Application for a Section 5 Declaration  
Development / Exempted Development

Postal Address or Townland or Location (as may best identify the land or structure in question)	CHURCH OF THE SACRED HEART, UPPERCHURCH, THURLES, CO. TIPPERARY.
	TIPPERARY CO. COUNCIL RECEIVED 21 NOV 2025

PLANNING SECTION  
FILE NO. 55/25/145

**Planning Ref.:** S5/25/145

REV.	DATE.	DESCRIPTION.
		CHURCH OF THE SACRED HEART, UPPERCHURCH, CO. TIPPERARY.
PROJECT		
TITLE	SECTION 5 DRAWING; VALLEY DETAIL	
CLIENT	UPPERCHURCH & DROMBANE PARISH	
SCALE	1:10 @ A4	DRG. No.
	Nov. 2025	3160 - (21)002

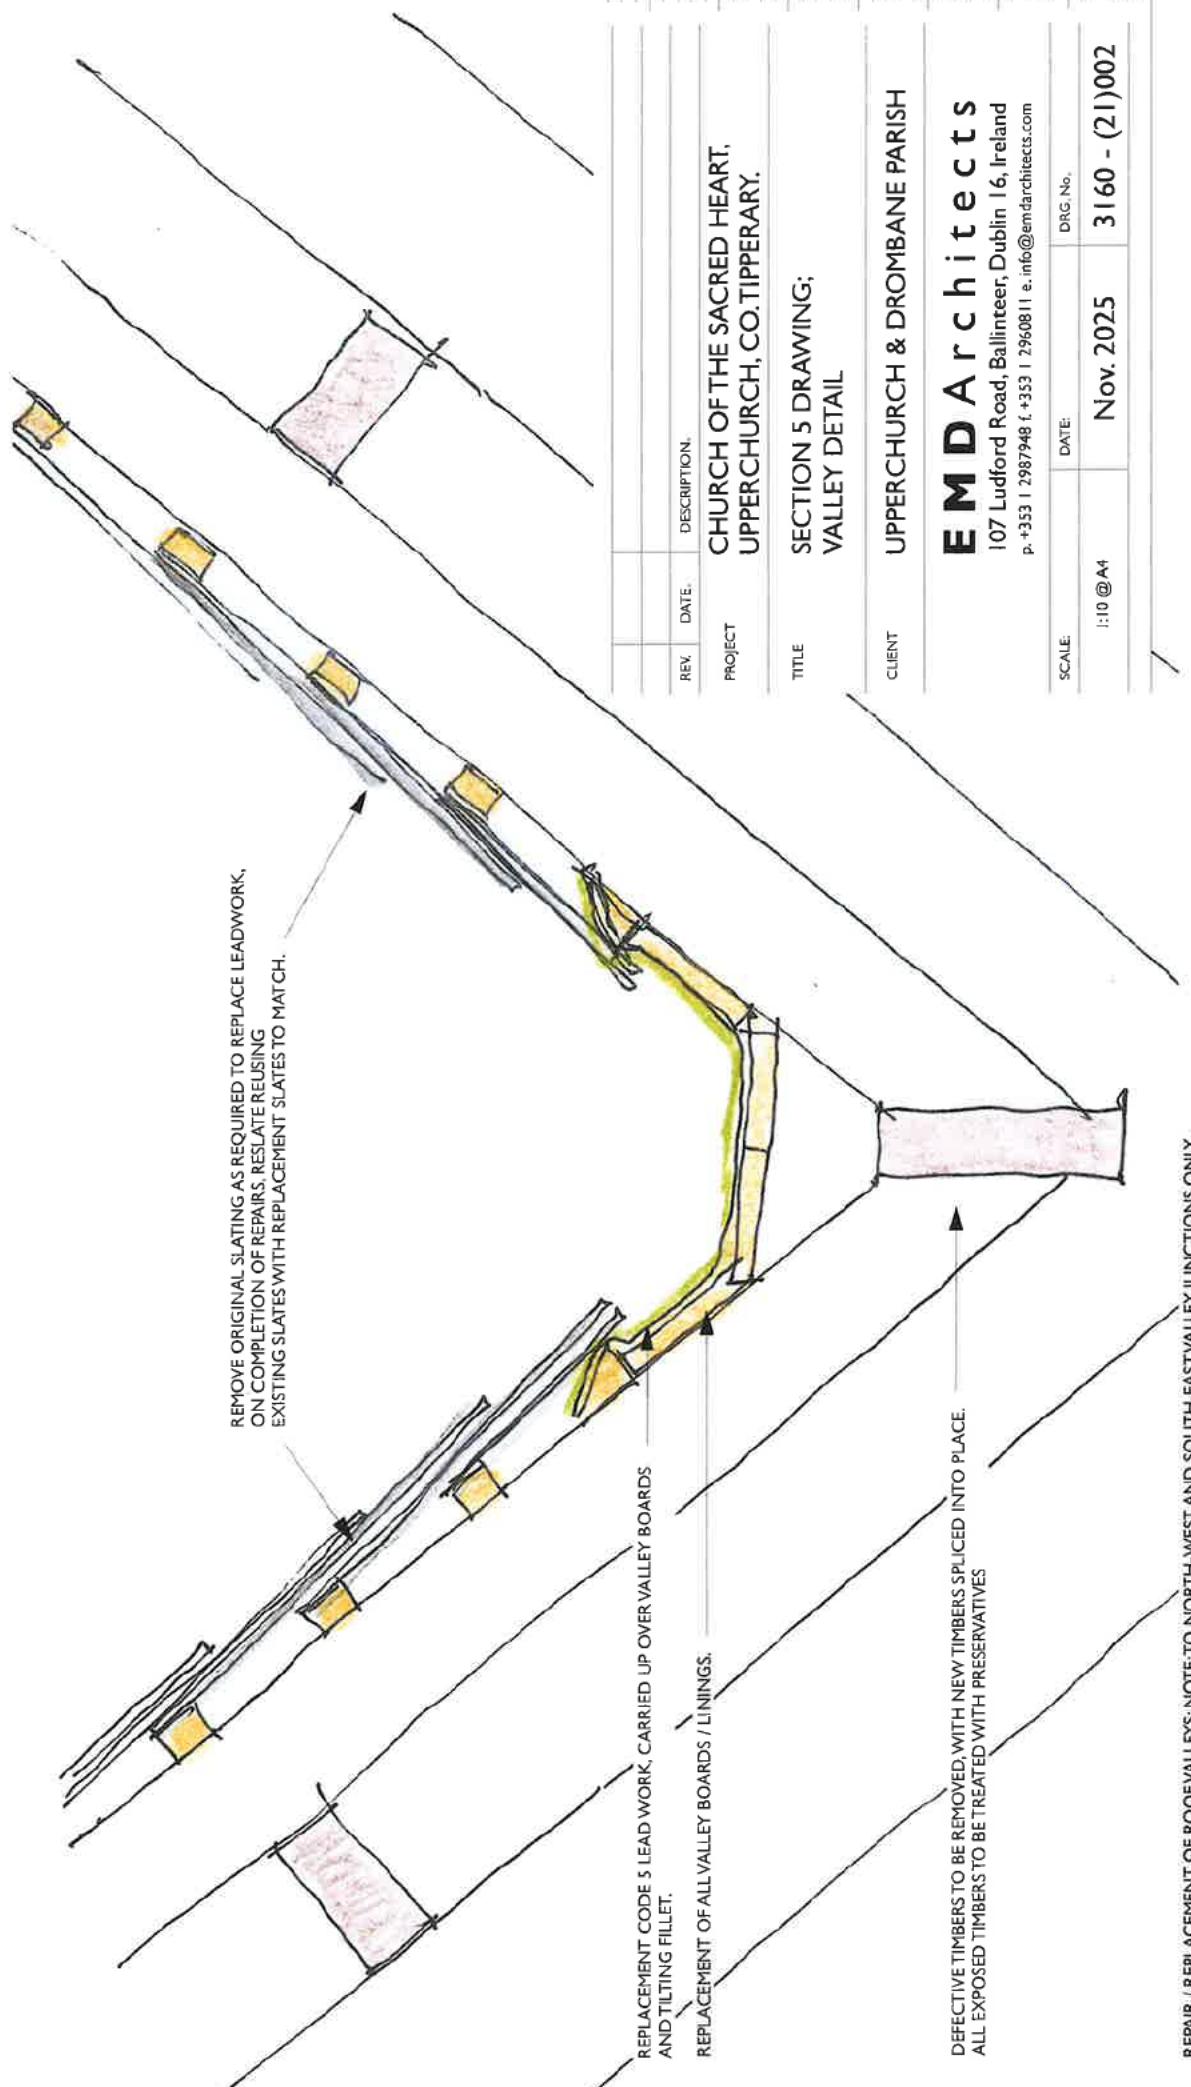
- 1. Drawn detail, to supplement the existing detail drawings, demonstrating and describing the proposed best-practice specification and crucial dimensions all of the lead valley and abutment flashing proposed as part of works that a Section 5 declaration of exemption is sought for.*

*The applicant should be advised that proposals to relay lead valleys to match the existing valley method is not acceptable as these existing valleys were clearly defective. Information in relation to minimum lead lengths between fixings, overlap detail, width of valley and height of lead lining beneath the edge of slates should conform to the best practice methods explained comprehensively on pgs 58-62 of Rolled Lead Sheet: The Complete Manual (2023 edition) published by the LSTA.*

We can confirm that the best practice methods and guidelines, published by the Lead Sheet Training Academy, shall be employed. With regard to the lead valleys, the guidance of the best practice methods in terms of length of lead between fixings, overlap detail, width of valley and the extent of lead carried under the slating. With regard to the abutment to the west gable, the existing flashings will be reviewed in detail during the proposed works, and if defective, these shall be replaced, adhering to best practice methods advised by the Lead Sheet Training Academy.

Attached are two copies of revised drawing no. (21)002A, which indicate the intended roof valley detail.

REV.	DATE.	DESCRIPTION.
		CHURCH OF THE SACRED HEART, UPPERCHURCH, CO. TIPPERARY.
PROJECT		
TITLE	SECTION 5 DRAWING; VALLEY DETAIL	
CLIENT	UPPERCHURCH & DROMBANE PARISH	
SCALE:	1:10 @ A4	DATE: Nov. 2025
		DRG. No. 3160 - (21)002A

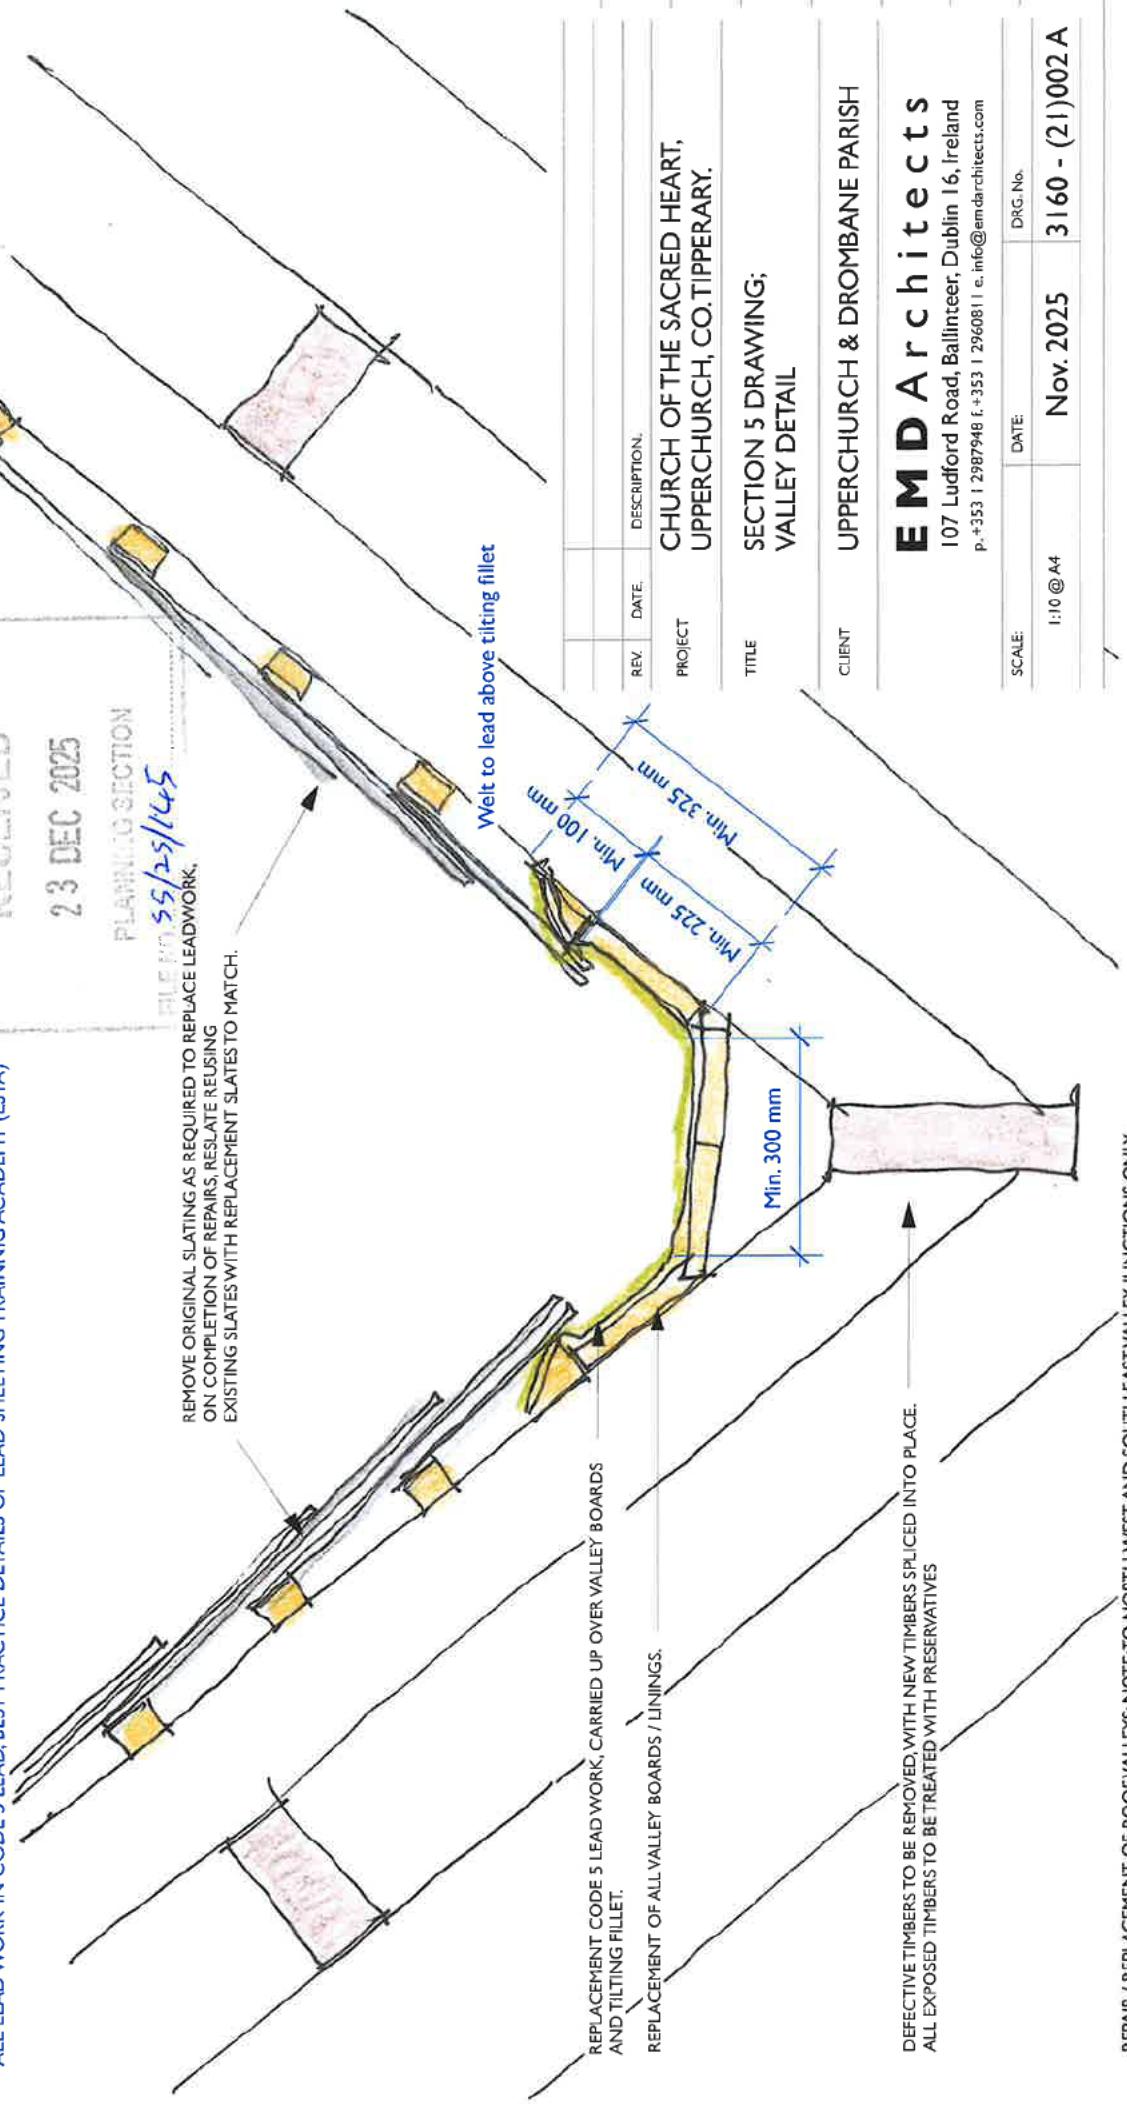
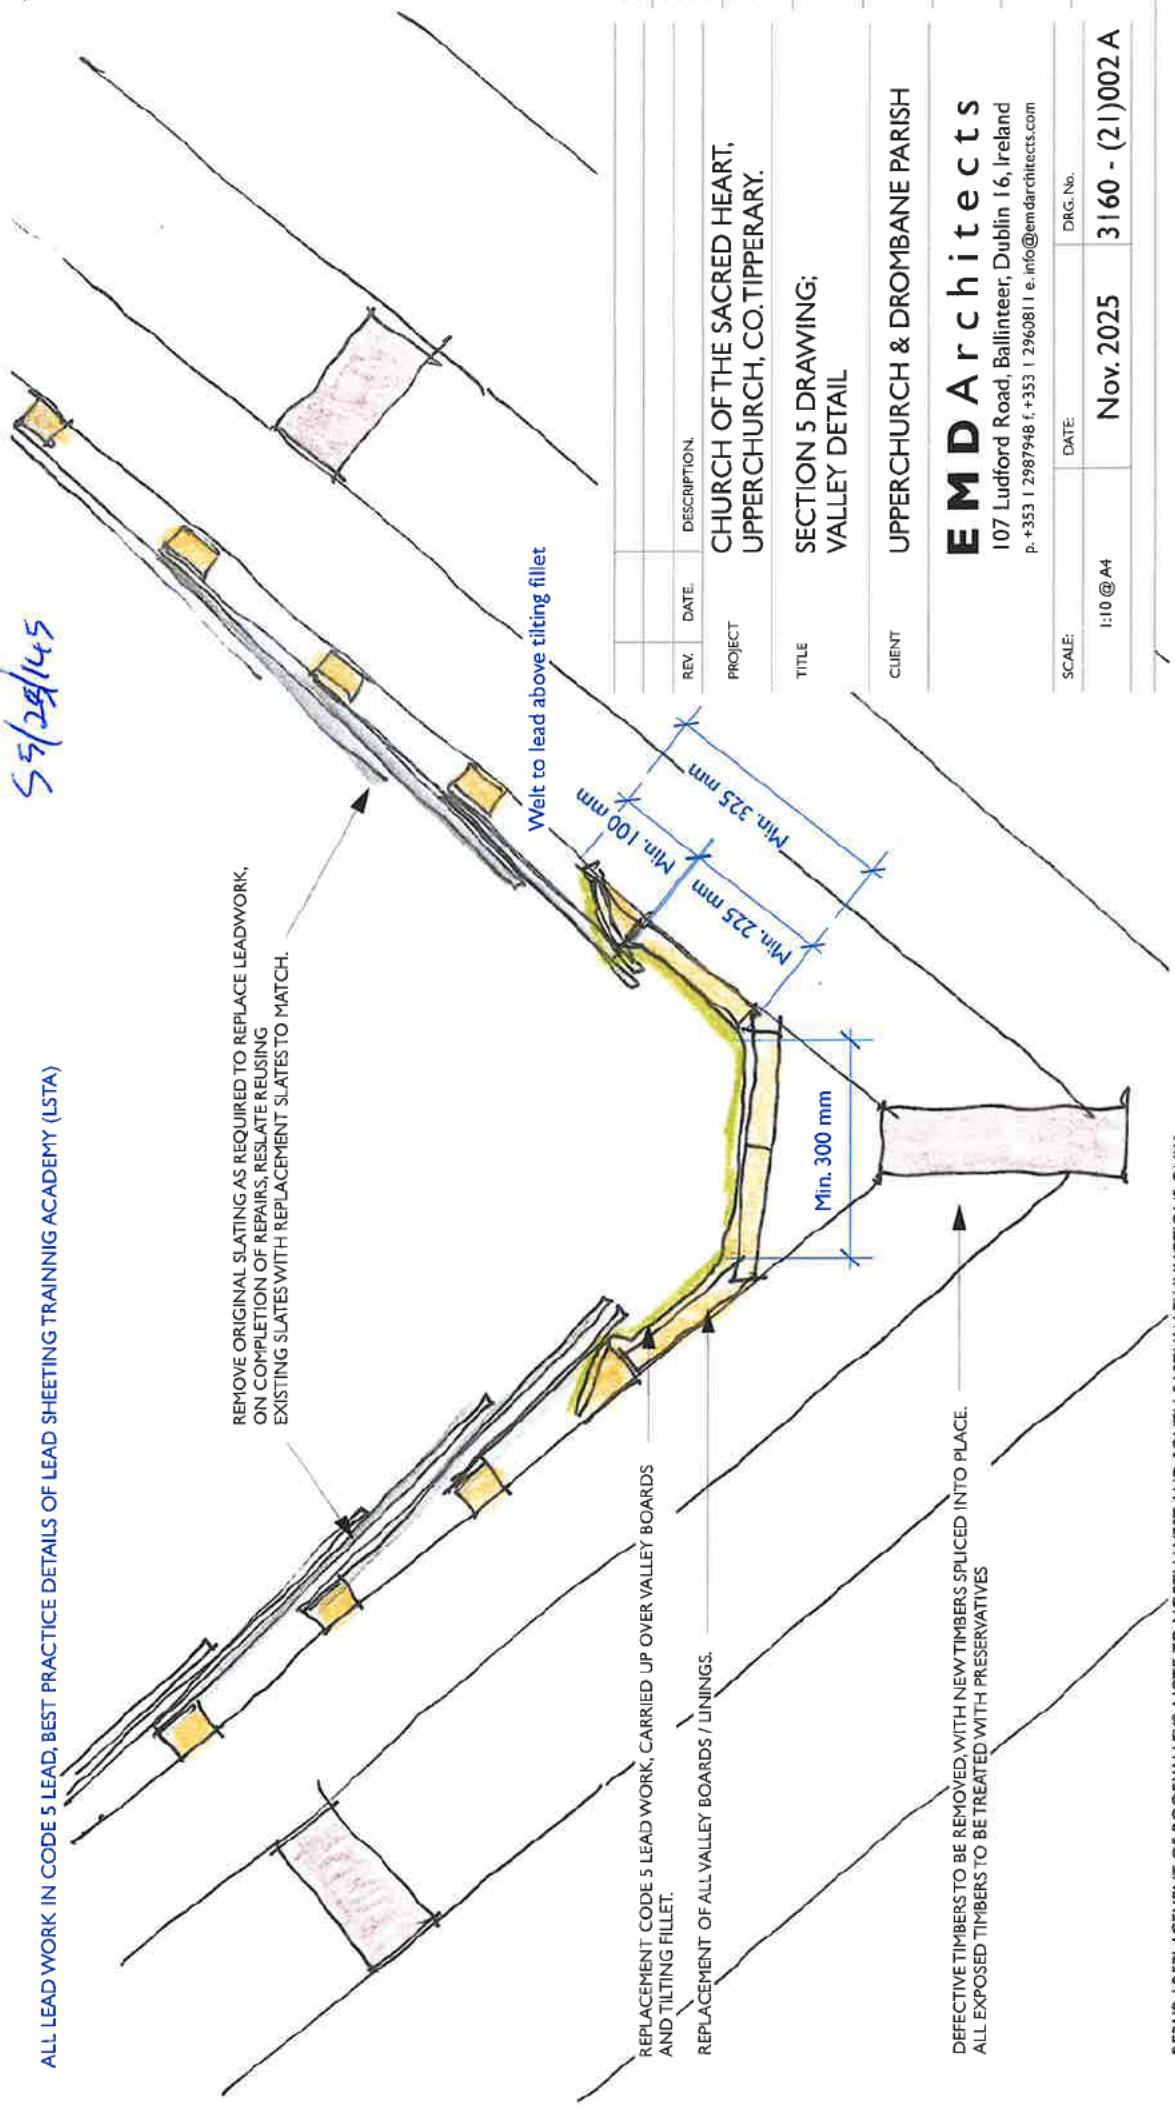
The applicant is requested to submit a drawn detail, to supplement the existing detail drawings, demonstrating and describing the proposed best-practice specification and crucial dimensions all of the lead valley and abutment flashing proposed as part of works that a Section 5 declaration of exemption is sought for.

The applicant is advised that the proposals to relay lead valleys to match the existing valley method is not acceptable as these existing valleys were clearly defective. Information in relation to minimum lead lengths between fixings, overlap detail, width of valley and height of lead lining beneath the edge of slates should conform to the best practice methods explained comprehensively on pgs 58-62 of Rolled Lead Sheet: The Complete Manual (2023 edition) published by the LSTA.

REMOVE ORIGINAL SLATING AS REQUIRED TO REPLACE LEADWORK,  
ON COMPLETION OF REPAIRS, RESLATE REUSING  
EXISTING SLATES WITH REPLACEMENT SLATES TO MATCH.
